Re: Interpretation for RZ 2001-SU-034 and RZ 2001-SU-035 (PI 0205-054)  
Rugby Road; footprints, architecture, and lot lines

Re: Request for Proffer Interpretation; Rugby Road; Rezoning 2001-SU-034; 035

Re: Proffer Interpretation Request; RZ 2001-SU-034, 035

Re: Proffer Interpretation Request; RZ 2001-SU-34 and 35

**LAYOUT PLAN**  
SECTION II/III

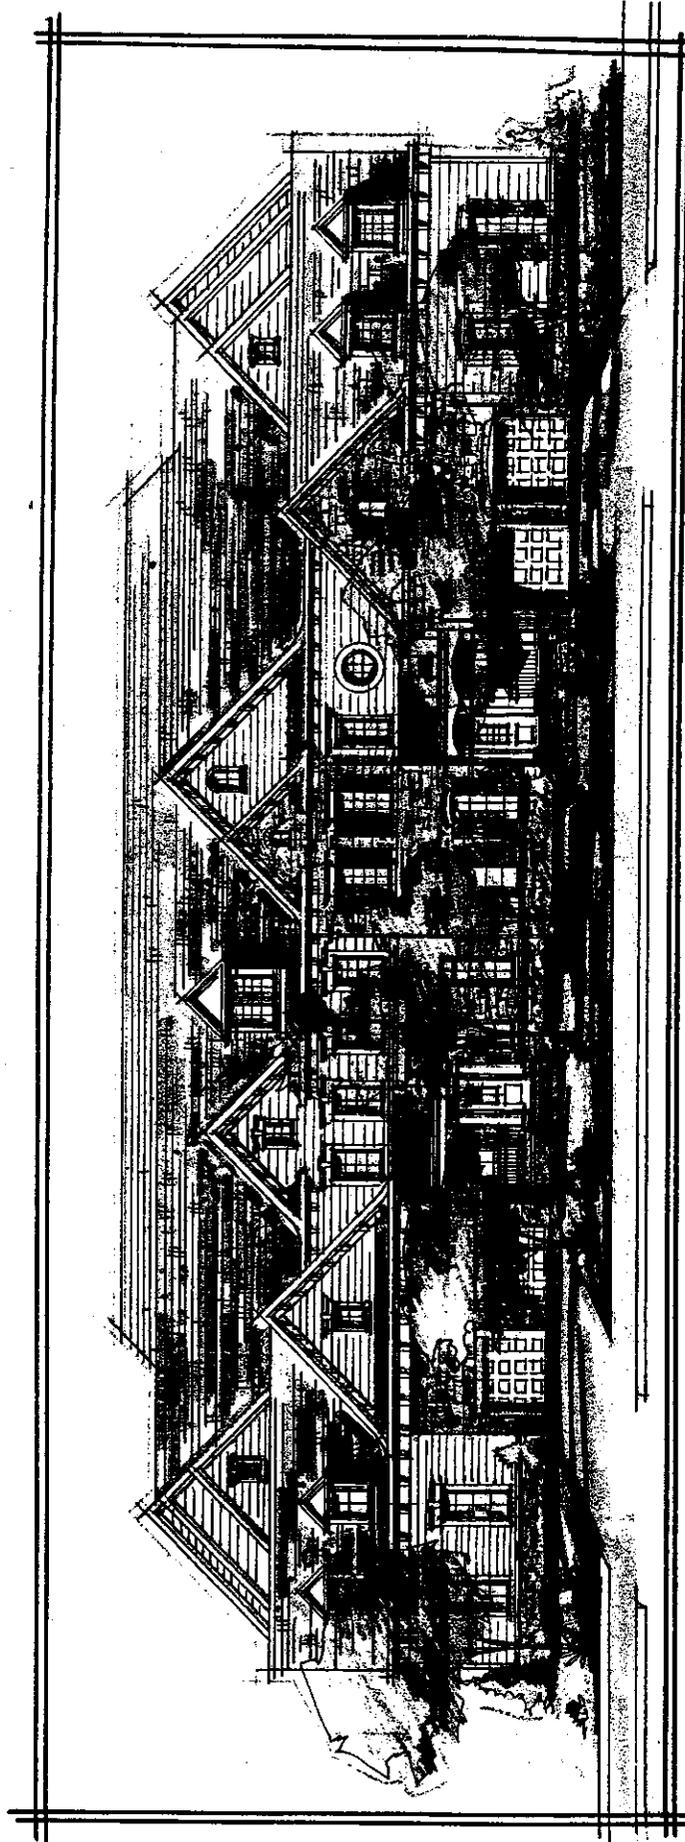
2. Approved GDP for Section II (Part of RZ 035) and III (RZ 034), with overlay depicting elimination of motor courtyard units with side entry garage units.

PROPOSED FRONT ELEVATION  
A  
RUGBY ROAD

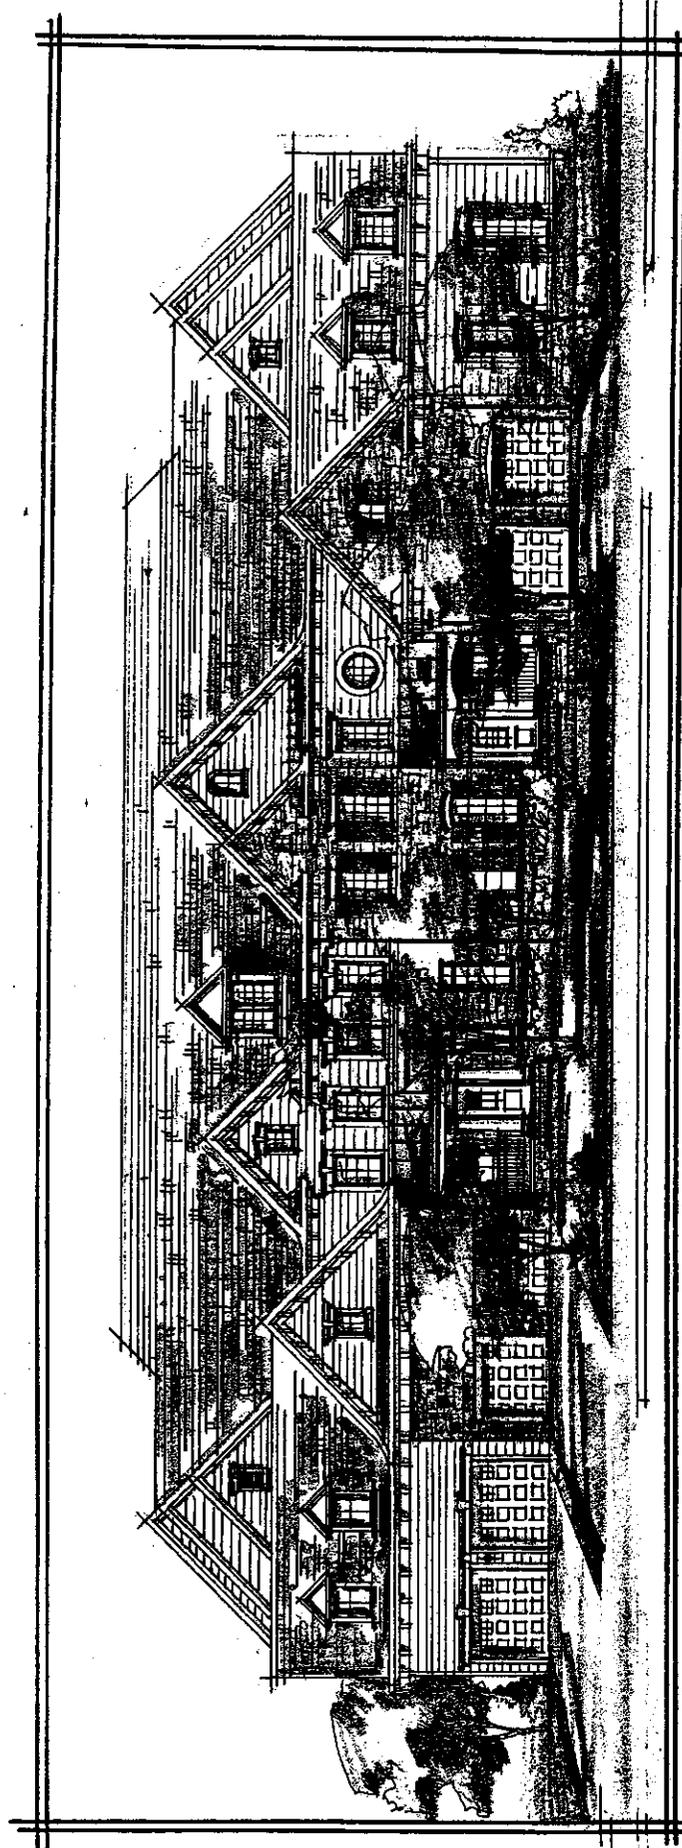
3. Architectural elevations of buildings as follows:
  - A. Approved elevation (market rate units);
  - B. Proposed Front Elevation A—depicts favorable comparison to A, above, in that a maximum of two sets of garage doors are displayed on building fronts. This elevation is accomplished by a design which employs side load garages for end units instead of the motor courtyards, enhancing the opportunity for planted green space on the building fronts. (See **plan key to location of Elevation A on overlay plans 1 and 2, above**). There are 11 buildings containing Elevation A units. Please note that the Elevation A unit on Tagger Circle proposes sharing its driveway entrance with the stormwater management access drive.

PROPOSED FRONT ELEVATION  
B

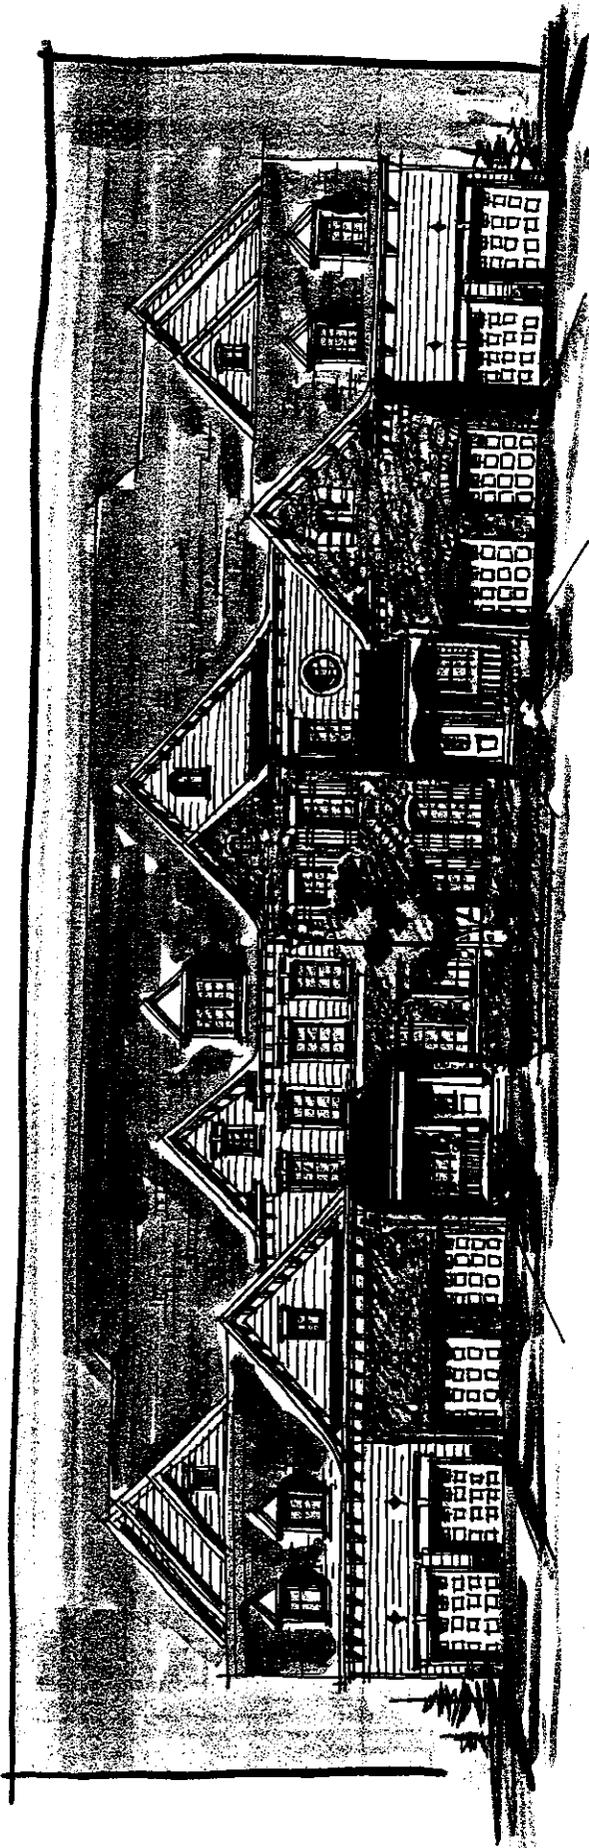
C. Proposed Front Elevation B– depicts also a favorable comparison to A, above. Although 3 sets of garage doors are displayed, the distance between the doors is visually separated by the enhanced green space. This elevation is accomplished by a design which employs one side load garage, dictated by spacing considerations. ( See plan key to location of Elevation B on overlay plans 1 and 2, above). There are 13 buildings containing Elevation B units.

FRONT ELEVATION  
C

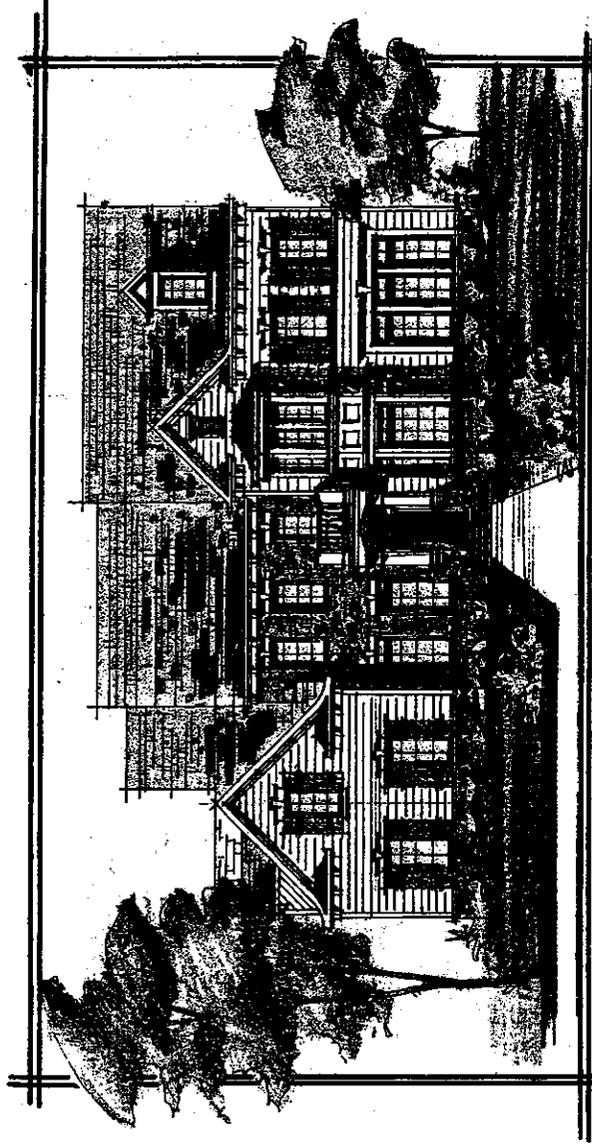
D. Proposed Front Elevation C– depicts front elevation with 4 sets of garage doors visible from the building front. We believe the added green space also ameliorates the appearance of these doors on the front, providing a visual break. Significantly, this elevation is present on one (1) building only which is located at the interior of the development and not visible from Rugby Road. Note also that this building, viewed from an end perspective, has the appearance of a single family detached unit. (See plan key to location of Elevation C on overlay plan 2, above).

RIGHT SIDE ELEVATION  
D

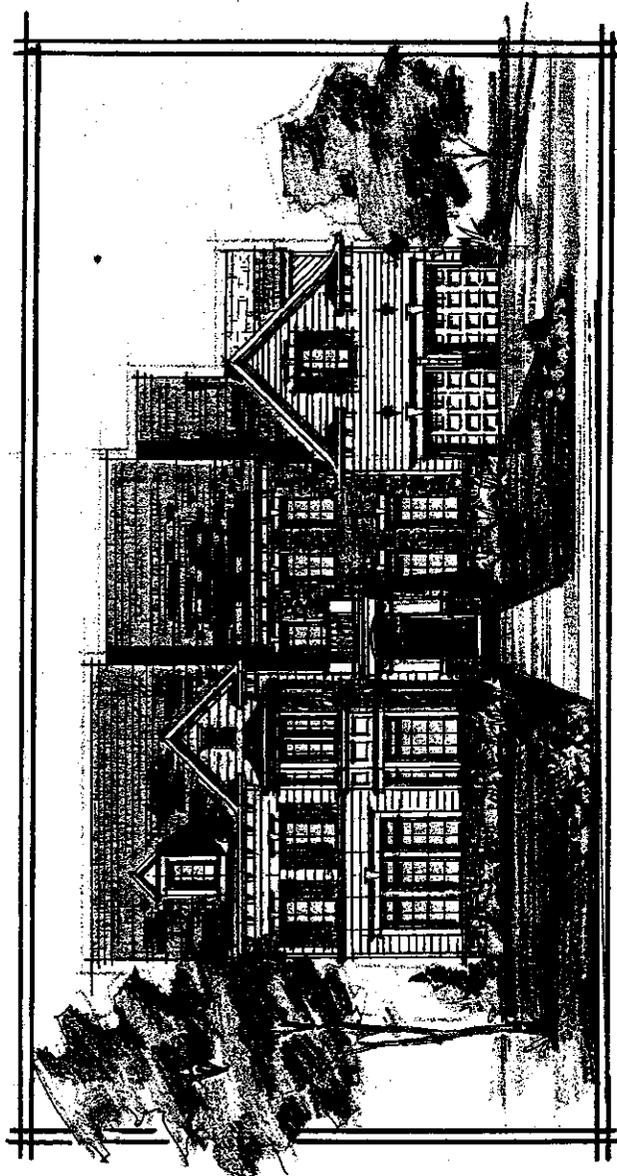
E. Right Side Elevation D/Left Side Elevation E– depicts the view of Elevation C viewed from the ends, an improved single family look with enhanced green space and planting opportunity.
